**Section 2550.7. General Water Quality Monitoring
and System Requirements.**

Comments on Section 2550.7:

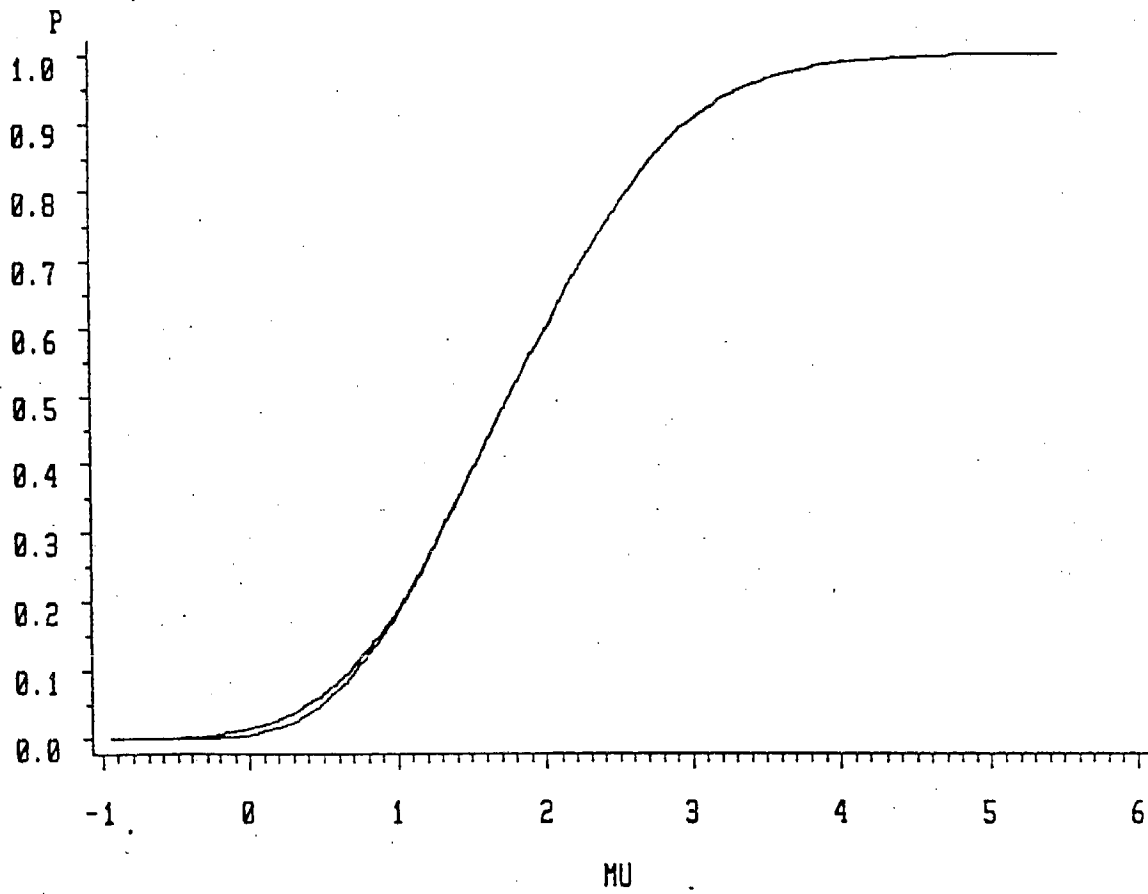
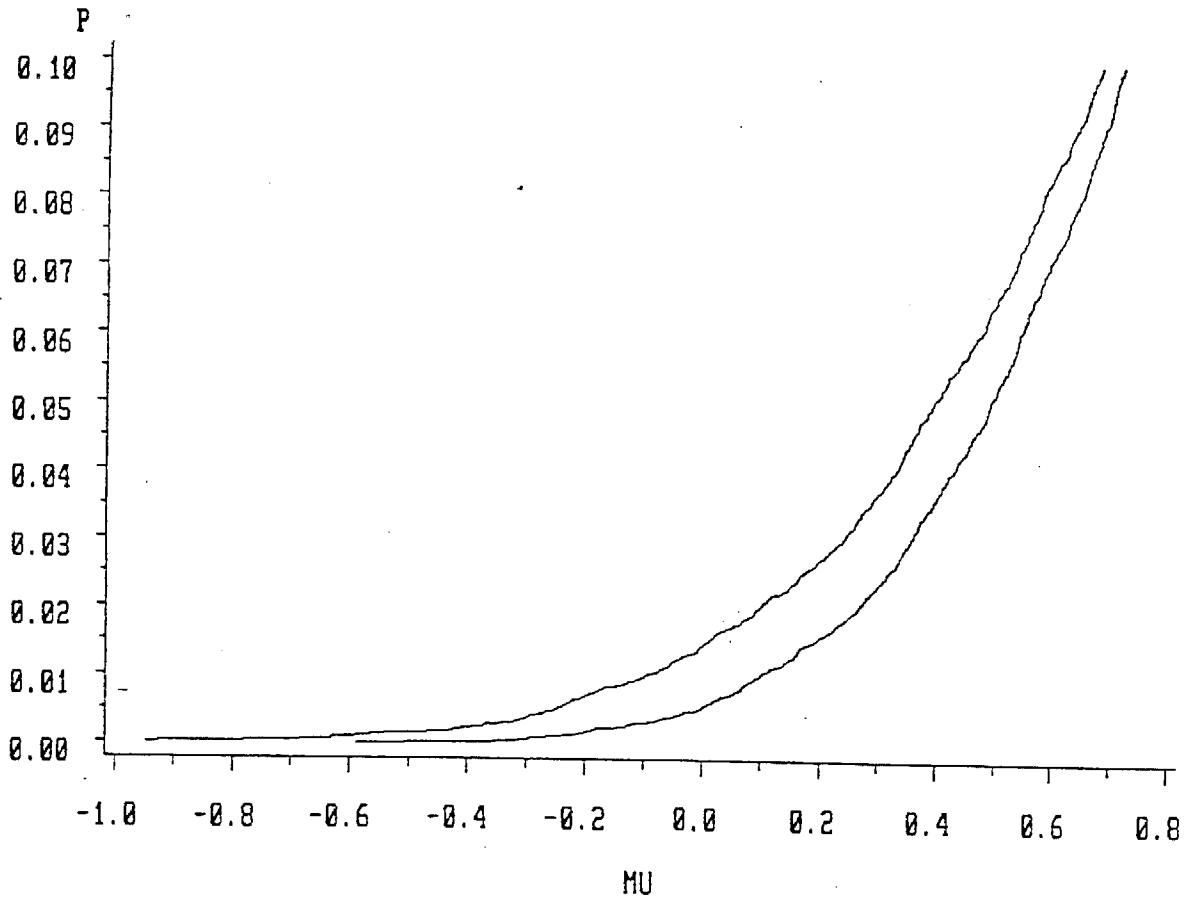
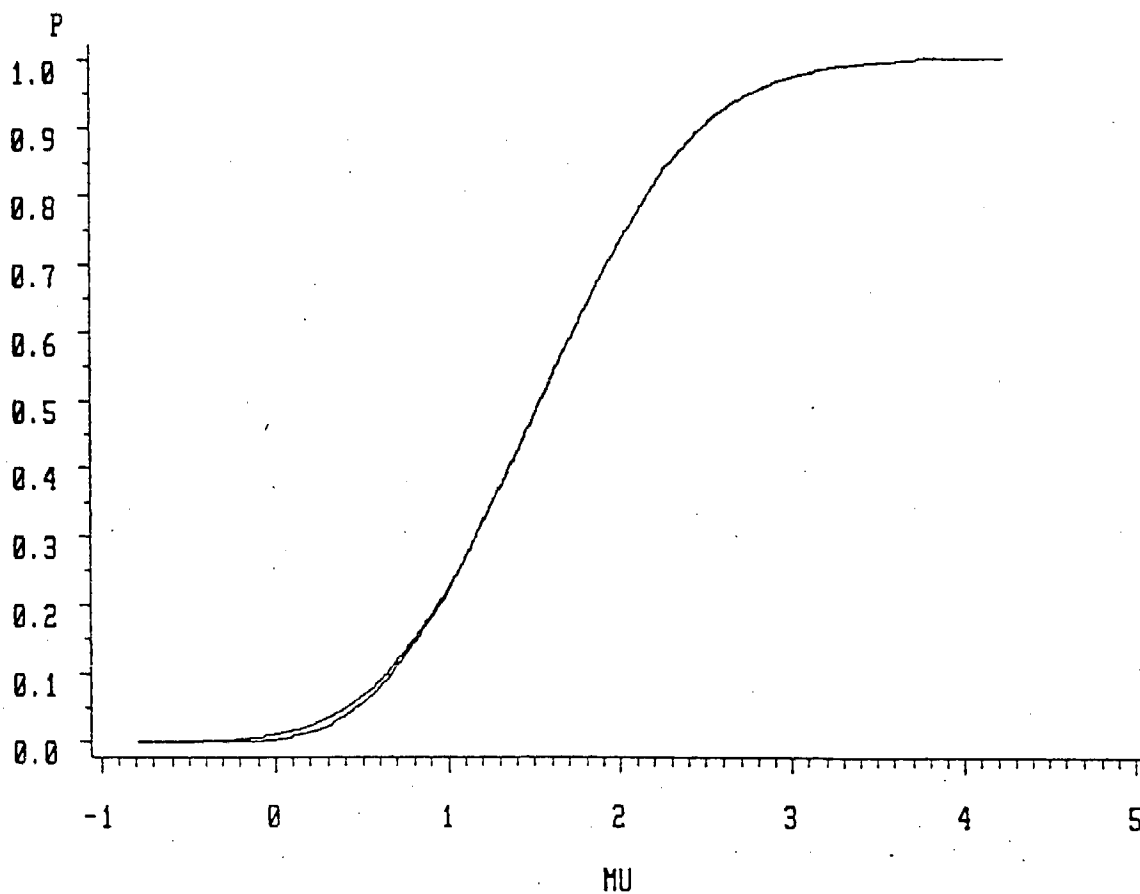
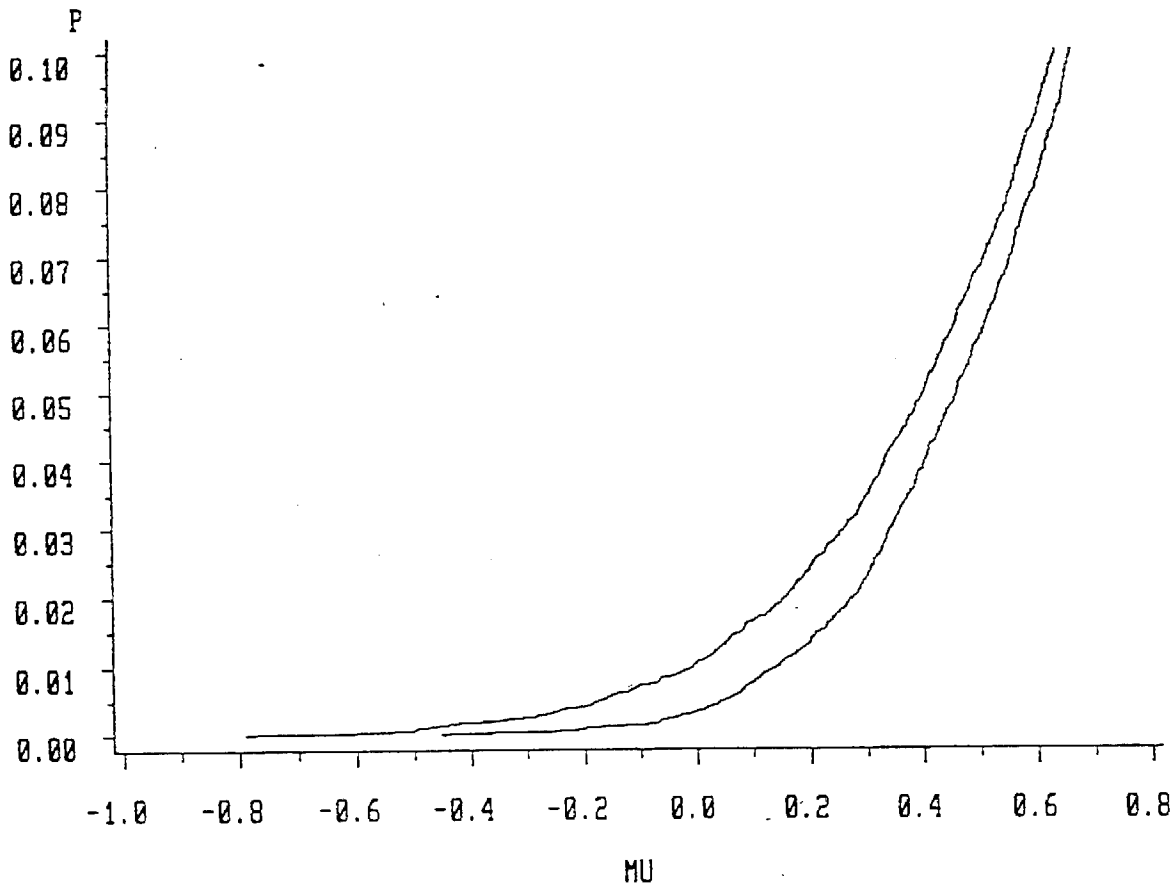
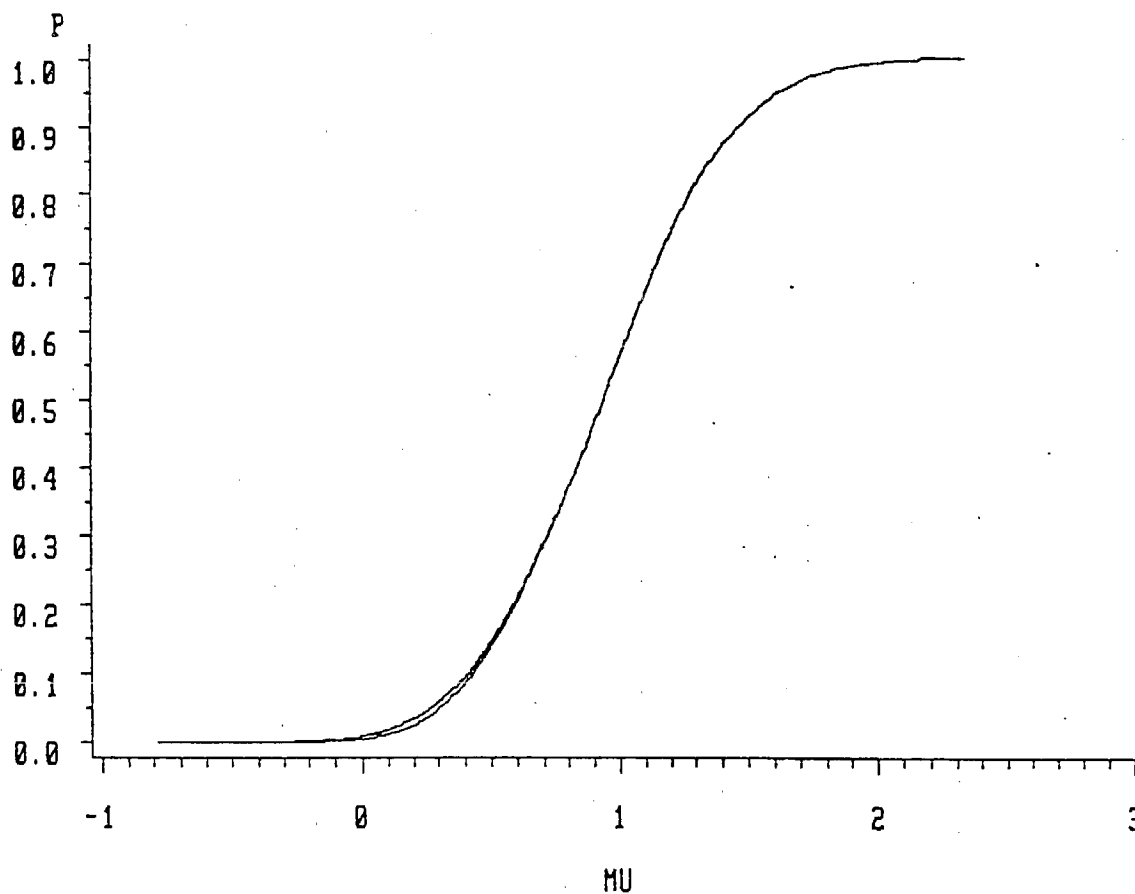
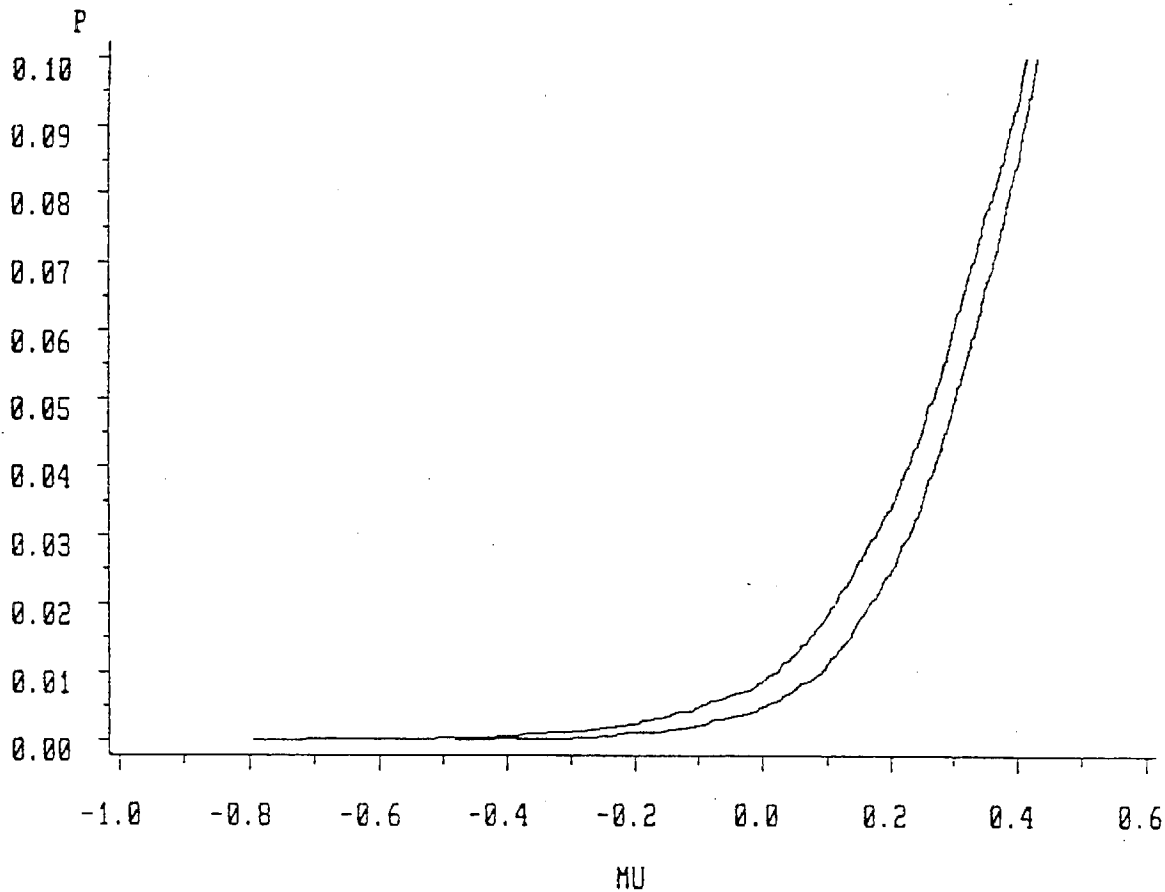
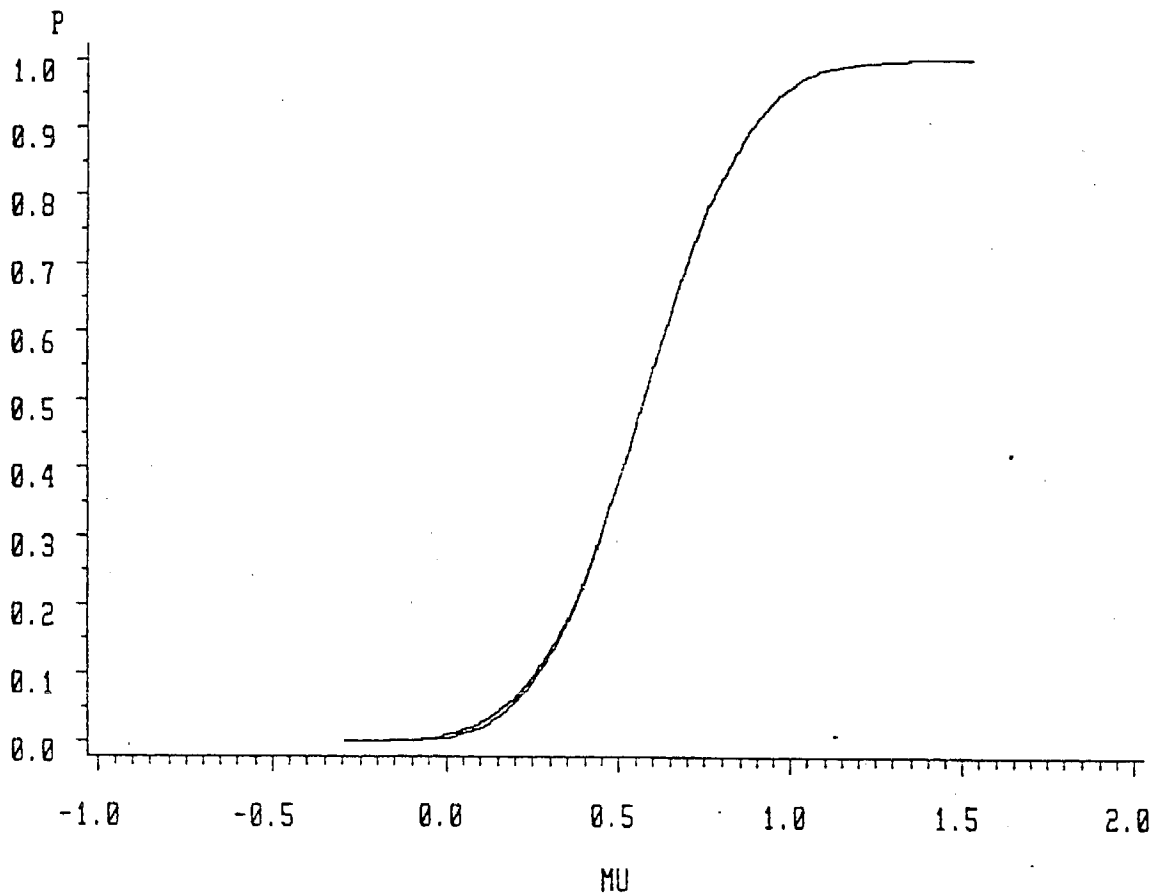
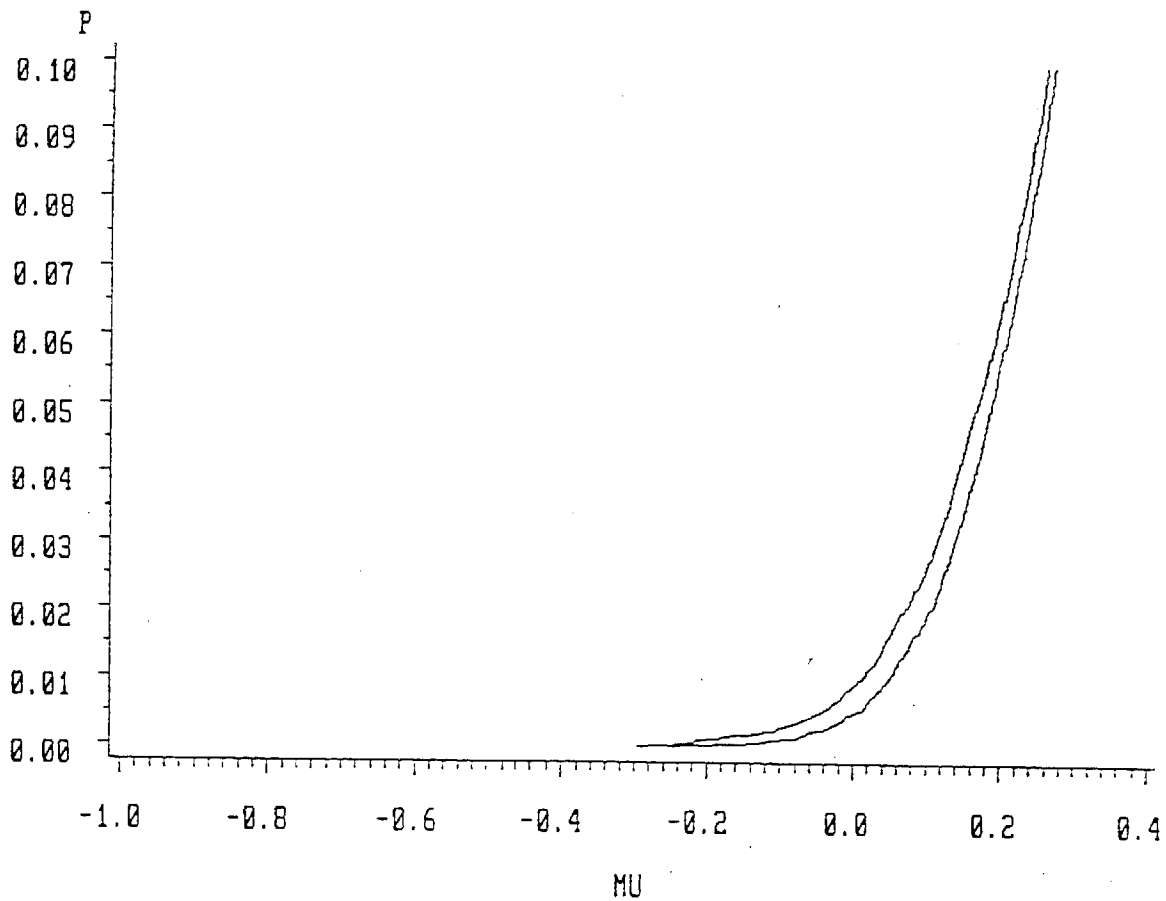
In order to provide a more technical support for the State Board's response to Region IX's comment, Dr. Willits' answer to the comment is included below, as excerpted from his September 25, 1989 letter to the State Board's Regulation Development Unit. The statistical power function graphs referred to by Dr. Willits in this letter are included as Figures 1A through 4B.

"There are two types of error involved in any statistical hypothesis test. First, in the context of testing for a release of toxic waste, the test could fail to detect a release that's actually present. This is what's referred to as a Type II error. Secondly, a test could falsely claim that a release had occurred, when it in fact had not. This is called a Type I error. Both of these types of error have serious consequences. Failure to detect can cause a more serious release of a toxic substance than would otherwise have occurred. On the other hand, a falsely identified release diverts resources away from the treatment of genuine releases, and frequent false alarms may cause the reaction to a true release to be one of skepticism rather than action.

"For a given sample size, there's an unavoidable tradeoff between these two types of error. In the current guidance document, EPA recommends keeping the Type II error probability low by maintaining a high Type I error rate. The problem with this strategy is that it allows for unacceptably high Type I error rates, which have their own consequences. For example, if a site operator had 10 down-gradient wells, each of which was being monitored for 10 constituents, then (assuming the individual tests were independent), then the probability of a Type I error for at least one of the comparisons would be $1 - .99^{100} = .634$. Thus this operator would be faced with false alarms nearly two thirds of the time.

"This situation provides the operator with a strong disincentive from maintaining an adequate monitoring network, since the Type I error increases with the number of tests, which is proportional to the number of wells. The way around this problem would be to use a testing procedure that has a lower Type I error rate. While it would be desirable to do so without causing any increases in the Type II error rate, this is not possible, as can be explained by the following argument. The probability of detecting an actual release (one minus the probability of a Type II error) is called the power of the test. The power is an increasing function of the magnitude of the release, so that releases that are very large in magnitude can be detected by virtually any statistical test. Moreover, the power, viewed as a function of the magnitude of the release is continuous, so that for very small releases, the likelihood of detection will be only slightly greater than the probability of falsely detecting a release when none is present. This latter quantity is the probability of a Type I error, commonly called alpha. Thus, any decrease in the Type I error from alpha to alpha' would necessarily cause an increase in the Type II error for an infinitesimally small release from $(1 - \alpha)$ to $(1 - \alpha')$.

"Whether or not this increase is acceptable can be judged only by looking at the power function. The power function for such a test is prohibitively complicated to calculate directly, so it must be estimated with the help of a computer. The attached graphs [Figures 1A, 1B, 2A, 2B, 3A, 3B, 4A, and 4B] indicate the power (P) of such a retest method based on t-tests, for various sample sizes
